Docket Item # 2
BAR CASE # 2010-00012

BAR Meeting
February 24, 2010

ISSUE: New Construction
APPLICANT: Alabama Avenue LC (Stephen Kulinski AIA, Agent)
LOCATION: 423 North West Street
ZONE: RB/Townhouse Zone

The applicant is requesting approval of a Certificate of Appropriateness for the construction of a new, two-story, detached row house with crawlspace on a vacant lot at 423 North West Street.

Figure 5: Front (West) Elevation

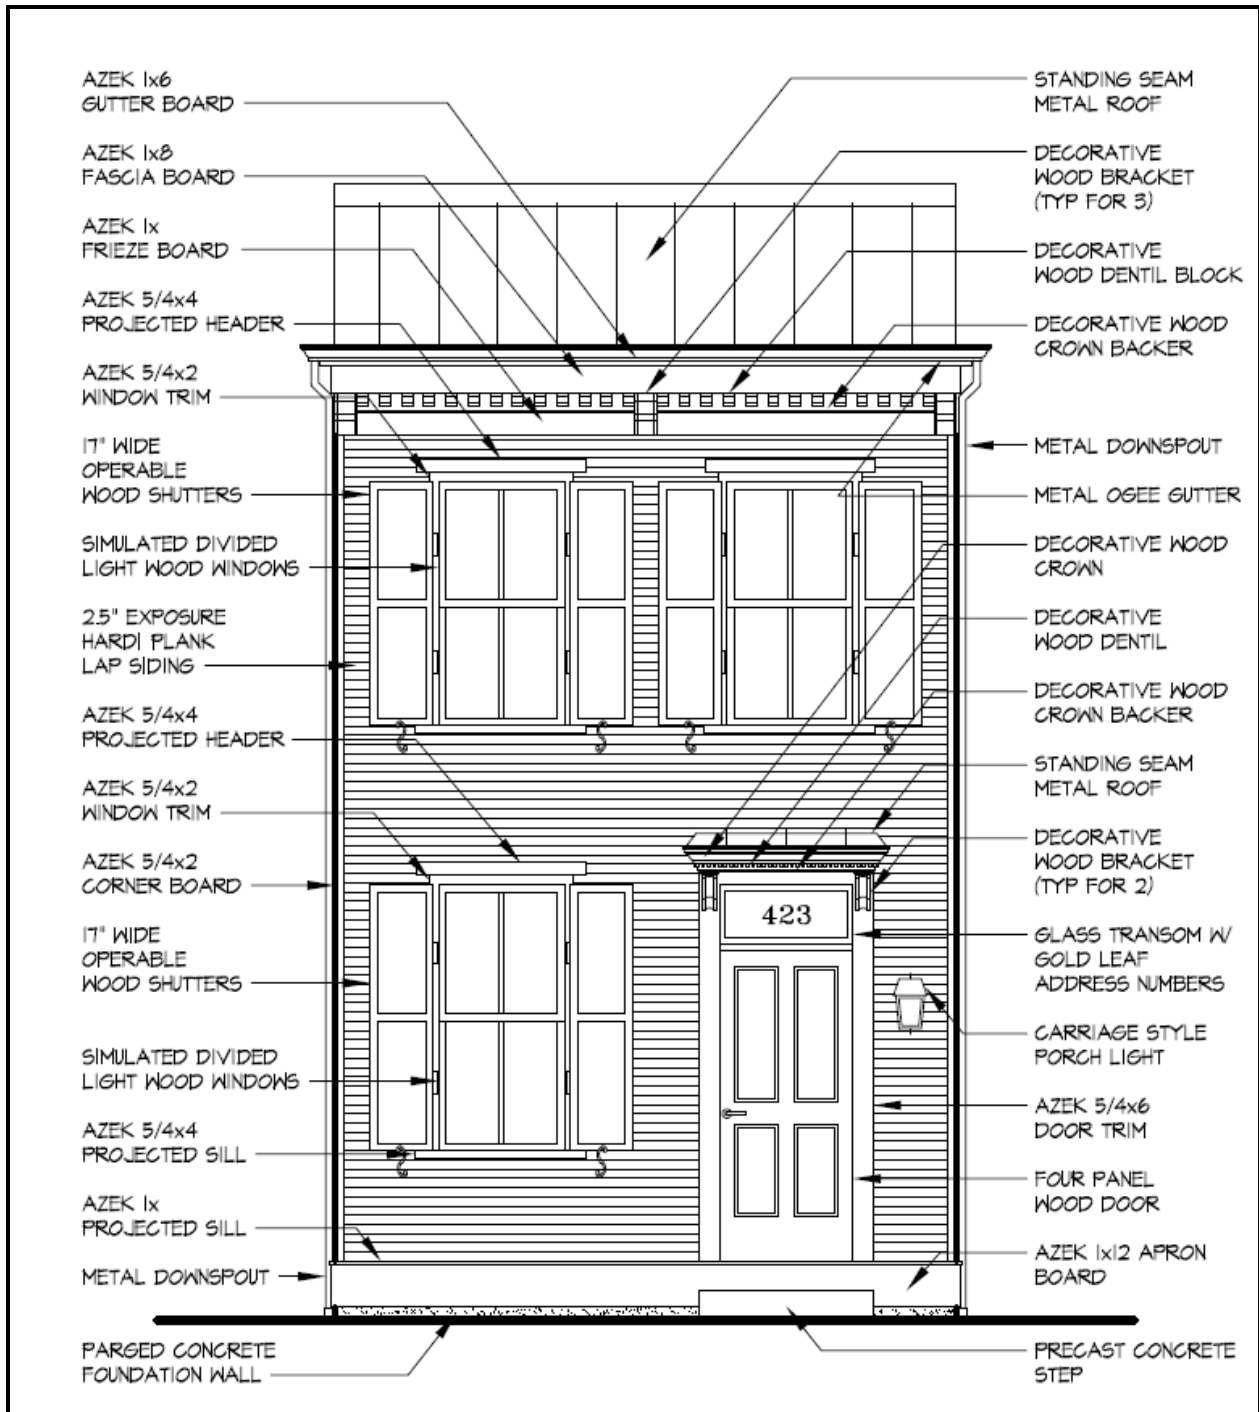
Front (west) Elevation – The front elevation of the building will be two bays wide with a front standing-seam metal mansard roof and a sloping EPDM membrane roof behind detailed with four flat skylights. The first floor of the front elevation will have a four-panel wood door with a single-light transom and a 2/2 simulated divided light wood window flanked with operable, two-paneled wood shutters. The two, wood windows on the second floor will also have a 2/2 light pattern. The building cornice will be detailed with a decorative wood crown, a 12" wide frieze board and brackets. The front elevation of the house will be clad with 2.5" exposure Hardi-plank lap siding. The mansard roof will be sheathed with standing seam metal and the trim throughout will be paintable, wood composite. The house will sit on a parged concrete foundation detailed with a 1' high projected sill. The front yard is landscaped with grass bisected with a concrete walk leading to the home's entrance which is adorned with a precast concrete step.

Staff supports the design as submitted with a recommendation regarding the standing seam metal roof material specification. A survey of Italianate houses with the mansard roof form in Alexandria indicates that the original roof material would most commonly have been slate or metal shingle. Standing seam metal roofs were a more typical treatment on hipped or gable roof forms. Staff understands that this project is new construction; however, since it is the goal of the applicant to utilize the replicative medium, Staff would encourage the applicant to consider metal shingle or slate for this small roof area as an alternative to the specified standing seam metal.

STAFF RECOMMENDATION: Staff recommends approval of the Certificate of Appropriateness application with the following conditions:
